Z-28
(2013)

PROJECT NAME:
4365 & 4365 S
FARM ROAD
SUBDIVISION

DRAWING TITLE:
ZONING PLAN

PETITION NO: Z-28

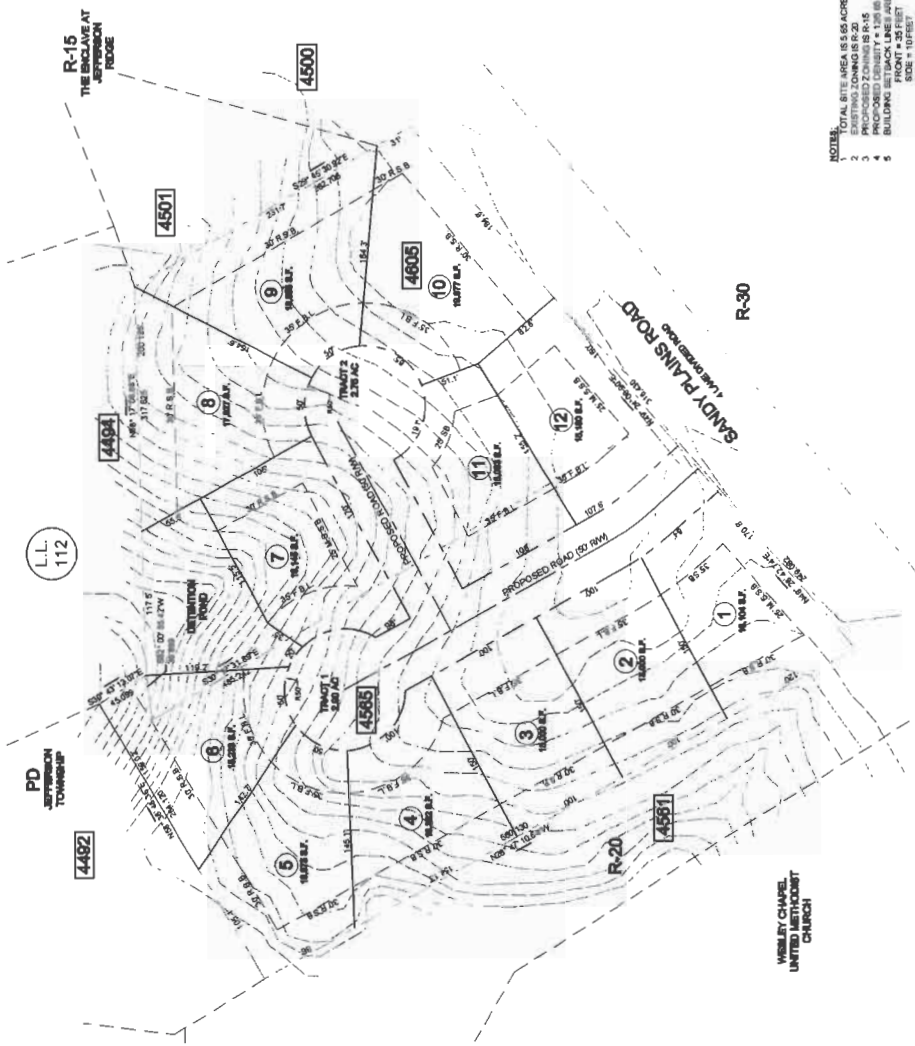
INSUFFICIENT INFORMATION

- No Stormwater controls shown _____
- Copy of survey is not current – Additional comments may be forthcoming when current site conditions are exposed.
- No site improvements showing on exhibit.

1. This parcel is located to the west of Sandy Plains Road. The majority of the site drains to the north directly into the Jefferson Township subdivision through two large lots. There is a natural drainage way leading to an existing 48-inch CMP private drive culvert, but no well-defined channel. A level spreader may be required for the proposed detention pond to lessen the impact of a concentrated discharge.
2. A drainage swale and easement will likely be required along the rear of lots 1-5 & possibly lot 8 to limit offsite runoff bypass.
3. A pre- and post-development sediment survey will be required for the downstream private pond.

Sandy Plains Road is classified as an arterial and according to the available information the existing right-of-way does not meet the minimum requirements for this classification.

Recommend applicant consider entering into a development agreement pursuant of O.C.G.A. 36-71-13 for dedication of the following system improvements to mitigate traffic concerns: a) donation of right-of-way on the north side of Sandy Plains Road, a minimum of 50' from the roadway centerline.

Recommend curb and gutter along both sides and sidewalk along one side of proposed development roadway.

Recommend a deceleration lane on Sandy Plains Road for the entrance.

- A. It is Staff's opinion that the applicant's rezoning proposal will not permit a use that is suitable in view of the use and development of adjacent and nearby properties. While there are R-15 properties in the area, applicant's proposed density is higher than those R-15 and R-20 properties developed in the past few years.

- B. It is Staff's opinion that the applicant's rezoning proposal will have an adverse affect on the usability of adjacent or nearby property. While there is an R-15 subdivision to the northeast of the subject property at 1.96 units per acre, applicant's proposed density slightly higher at 2.12 units per acre. The proposed density is also higher than a recent nearby R-20 development that has a density of 1.15 units per acre.

- D. It is Staff's opinion that the applicant's rezoning proposal is not in conformity with the policy and intent of the *Cobb County Comprehensive Plan*, which delineates this property to be within the Very Low Density Residential land use category having densities ranging from 0-2 units per acre. Applicant's proposed density is 2.12 units per acre. Other zonings and densities in the area include two portions of Jefferson Township (Phases 1 and 10) having densities of 0.47 units per acre and 0.59 units per acre respectively; Mountain Creek Estates, nearby on Mountain Road, zoned R-20 (Z-11 of 2011), with a density of 1.15 units per acre; The Enclave at Jefferson Ridge, east of subject property, zoned R-15 (Z-42 of 2003), having a density of 1.96 units per acre; and Jefferson Park, across from The Enclave at Jefferson Ridge on Sandy Plains Road, zoned R-15 having a density of 2.06 units per acre. Applying the density average from the Zoning Ordinance for the R-20 category, nine units could be developed yielding an approximate density of 1.59 units per acre.
